# Broadcast Products Technical Bulletin 20-2003-245

DATE: **December 1, 2003**SUBJECT: **REUSE IC3 WHEN REPLACING HZ BOARD**

MODEL: **BVM-1311**  
**BVM-1316**  
**BVM-1316C**  
**BVM-1411P**  
**BVM-1911**  
**BVM-1916**  
**BVM-2011P**  
**BVM-2811**

**Figure 1**

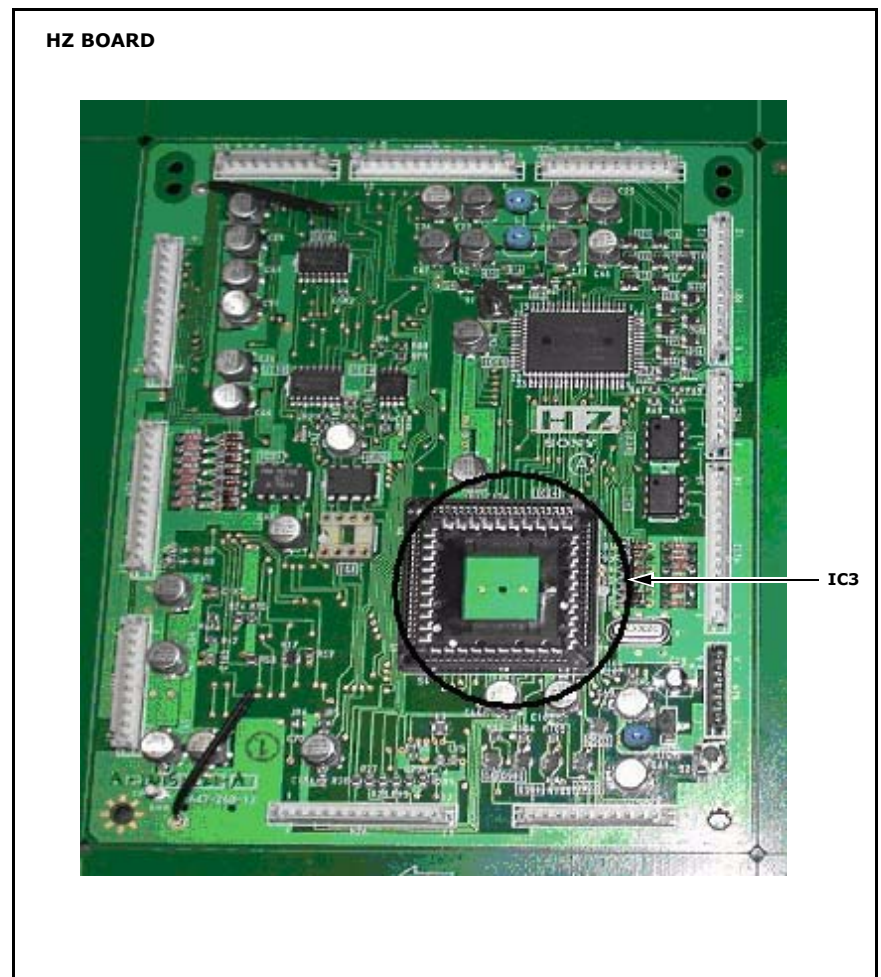
When replacing the HZ board (A-1375-121-A), remove IC3 (8-759-164-54) from the former board and install it on the new board.

The new HZ board does not contain IC3, and IC3 is no longer available as a service part. (See Figure 1.)
